**AMENDMENT THREE TO THE HAYES-WEST FREMONT
138 kV TRANSMISSION LINE PROJECT**

OPSB CASE NO.: 16-1595-EL-BTA

July 28, 2016

The attached Letter of Notification Application is the Third Amendment to the Hayes-West Fremont 138 kV Transmission Line Project and proposes seven adjustments to the Approved Route. The proposed adjustments are described in detail in the application.

FIGURE 4-1D
CONSTRAINTS MAP
REVISION 1

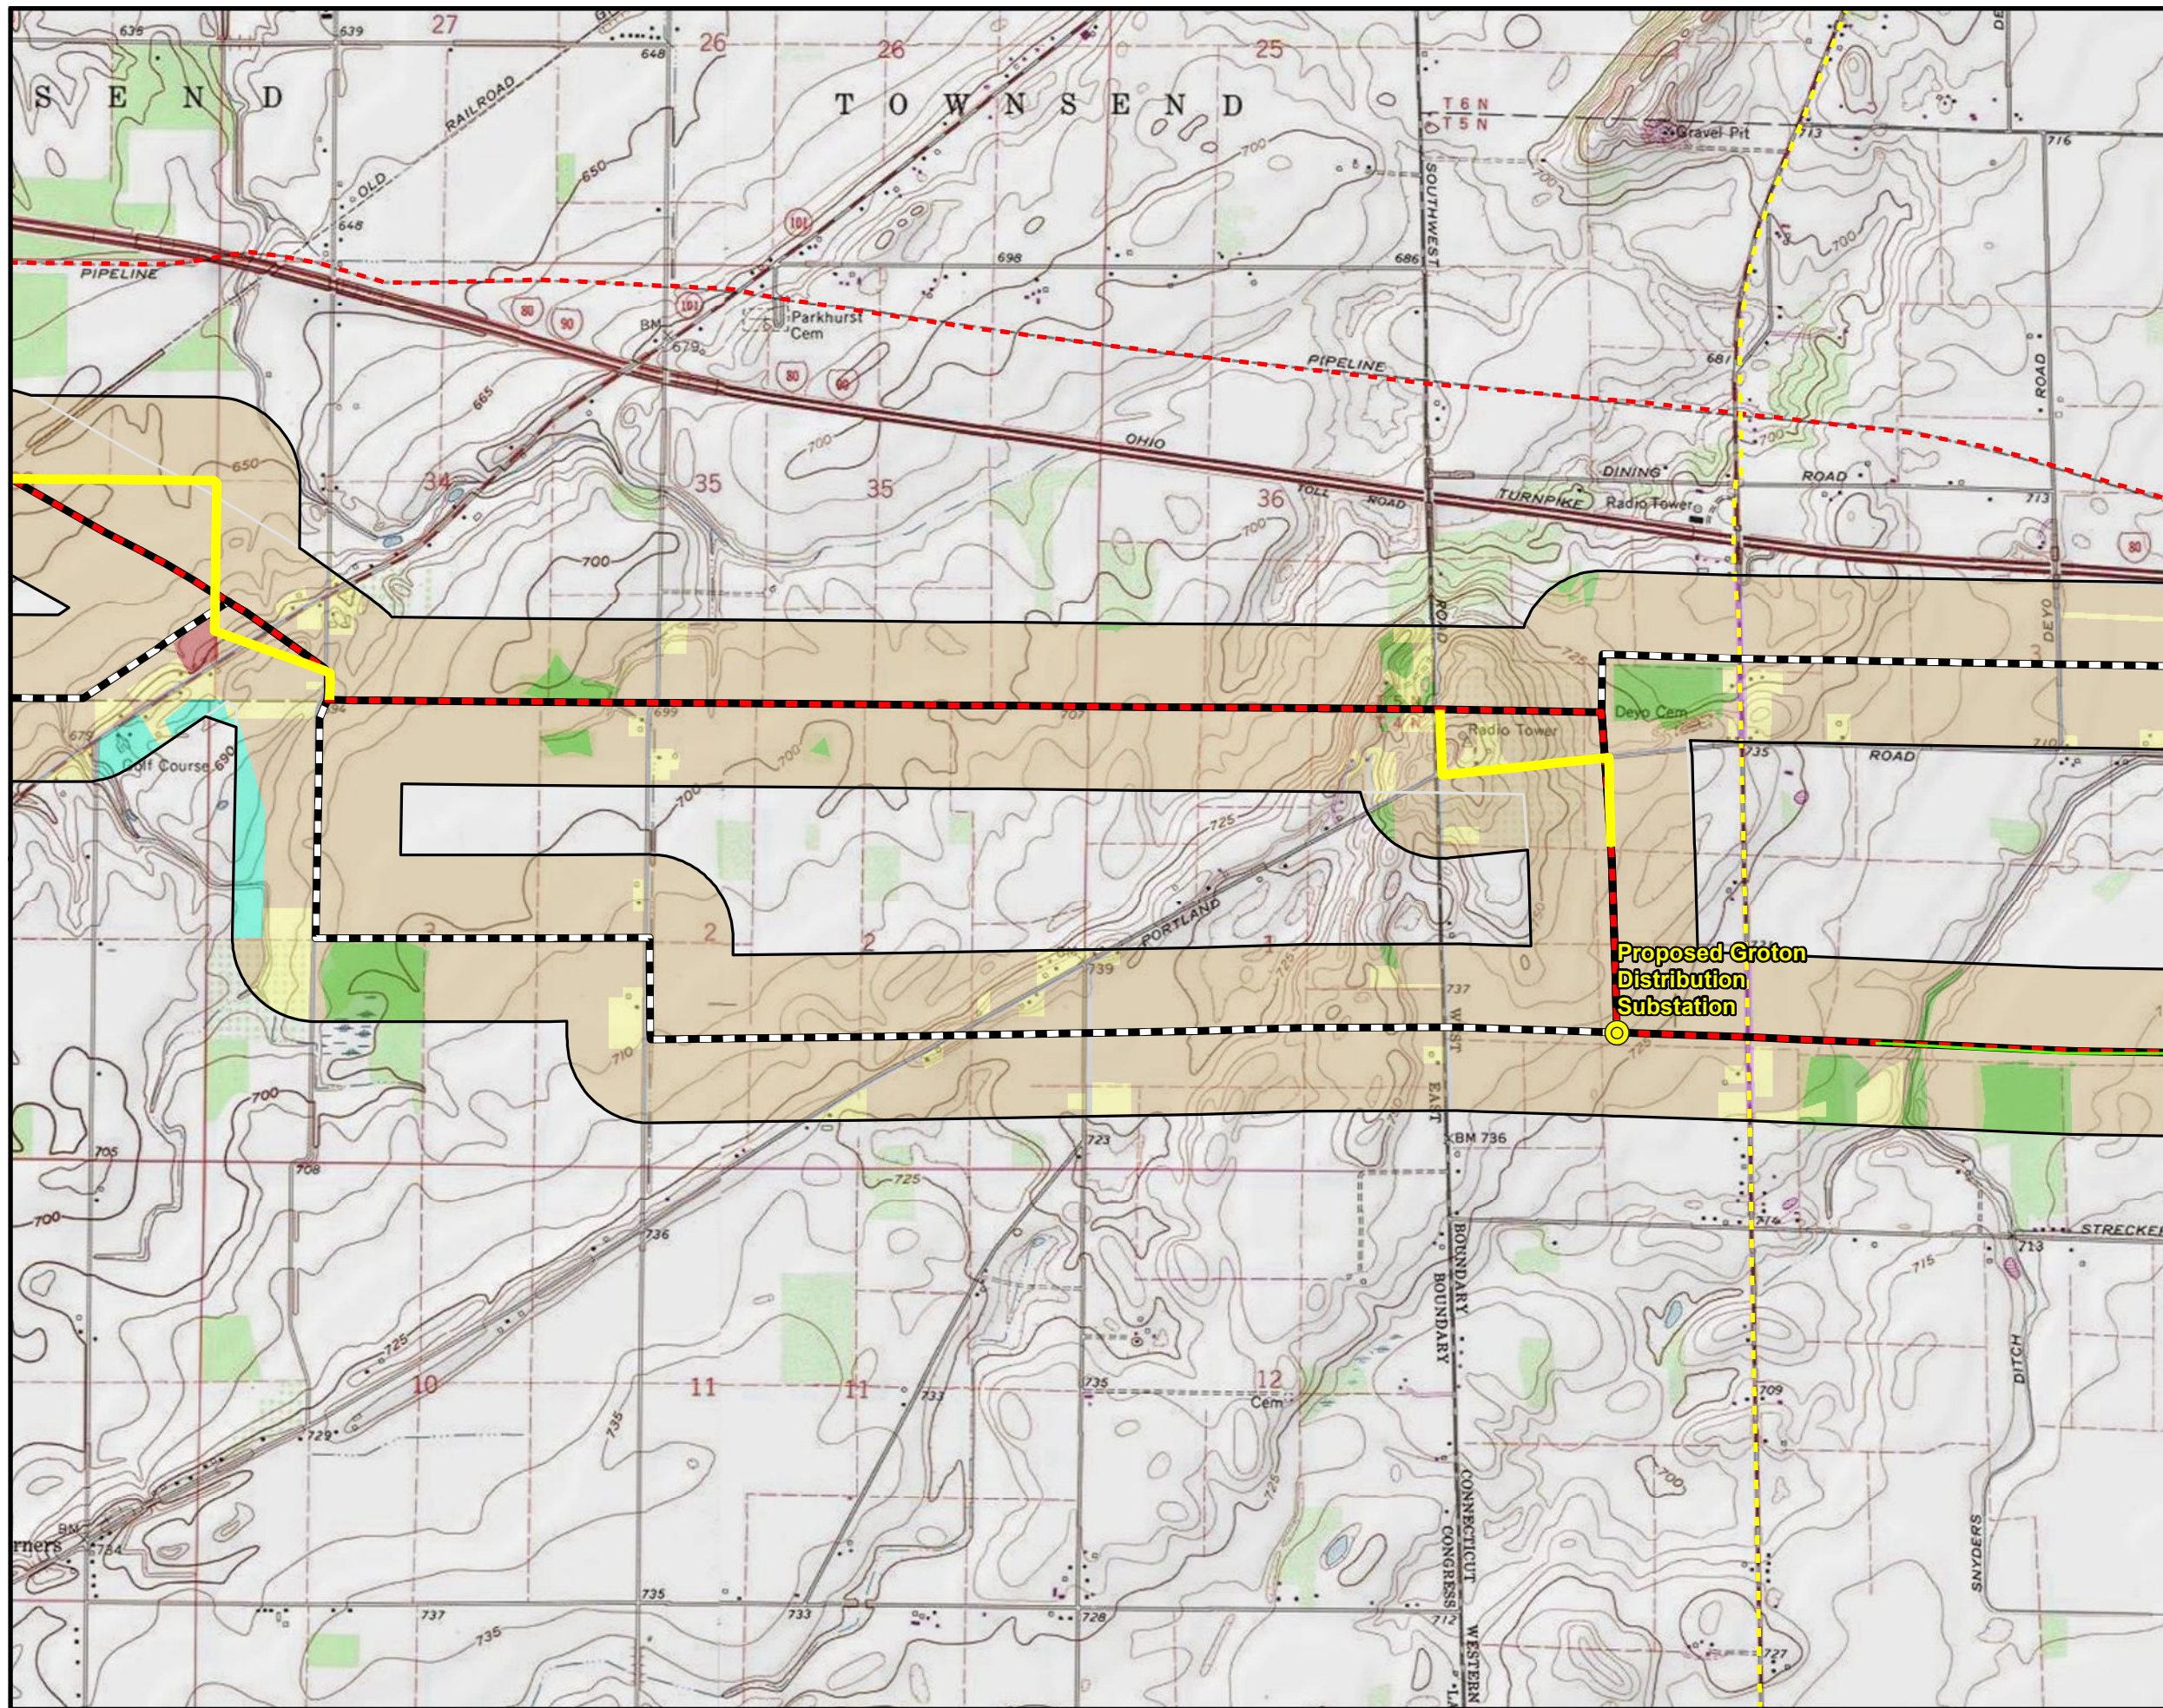
As shown in Figure 4-1D Revision 1, Land Use and Constraint Map Route OPSB Approved Route, approximately 1,100 feet south of the intersection of the OPSB Approved Route and Portland Road, the two poled guyed angle structure is proposed to change to a tangent structure resulting in a shift of the centerline immediately south of the intersection of the OPSB Approved Route and Portland Road approximately 50 feet to the east of the previous intersection. At this point, just south of the intersection of the OPSB Approved Route and Portland Road, a 90 degree corner dead-end structure will be installed and the route will head west paralleling Portland Road on the south side approximately 2,100 feet to another 90 degree corner dead end structure adjacent to the intersection of Portland Road and Northwest/Southwest Road. At this point the route turns north and proceeds approximately 780 feet and reconnects to the OPSB Approved Route via another 90 degree corner dead-end structure. These changes to the route in this location are at the request of the property owner and are reflected in the easements.

As shown in Figure 4-1C Revision 1 and Figure 4-1D Revision 1, Land Use and Constraint Maps Route OPSB Approved Route, beginning on the east side of the intersection of the OPSB Approved Route and Pickle Street and extends to the intersection of the OPSB Approved Route and Mugg Road, the route is proposed to shift south approximately 12 degrees and trend in a west-northwest direction.
